T-SB-0160-11

Secondary Air Injection System - Water Intrusion: MIL "ON" DTC P0418, P0419, and/or P244#

YEAR(S)	MODEL(S)	ADDITIONAL INFORMATION
2008 – 2011	Sequoia	
2007 – 2011	Tundra

The information contained in this bulletin supersedes SB Nos. T-SB-0329-08 and T-SB-0350-09.

Figure 1.

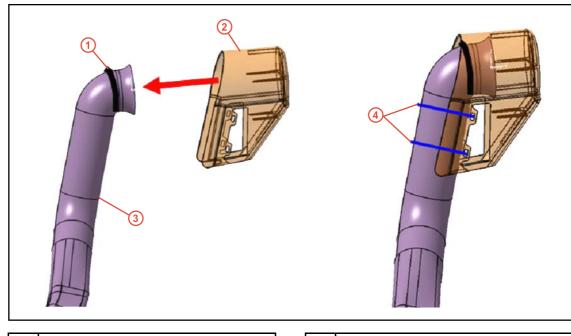
FOR 2UZ-FE EQUIPPED VEHICLES

- ONLY replace the Bank 2 pump.
- Install the foam seal to the top of the air inlet along the inlet's edge and then attach the
 cover with zip ties as shown below. The zip tie length should be a minimum of 2.5 in.
 (64 mm) in length when tightened.

Figure 2. 1GR-FE/3UR-FE/1UR-FE Air Injection Pump Assembly (with clamps)

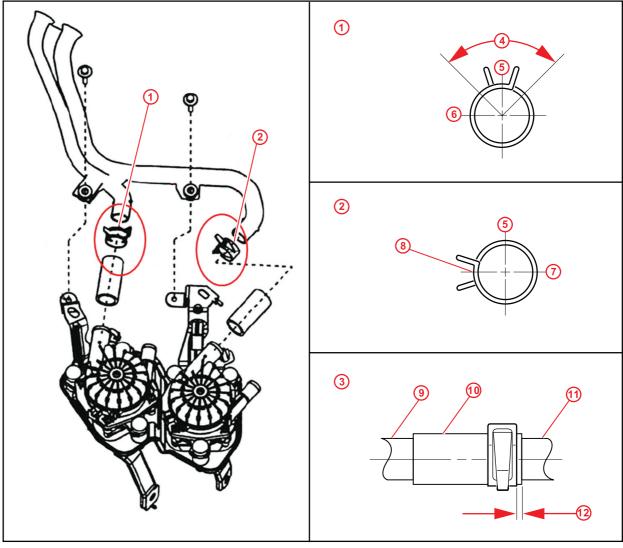
- B. Install the inlet cover (2UZ-FE only).
- C. Replace all air pumps under the fender well.
- D. Install clamps on the inlet pipe to air pump hose joint where not currently installed, as shown in Figures 2 and 3.

Make sure the clamp orientation is as shown in Figures 2 and 3.

ONLY install clamps on vehicles where they are not currently installed. If already present, reuse the currently installed clamps.
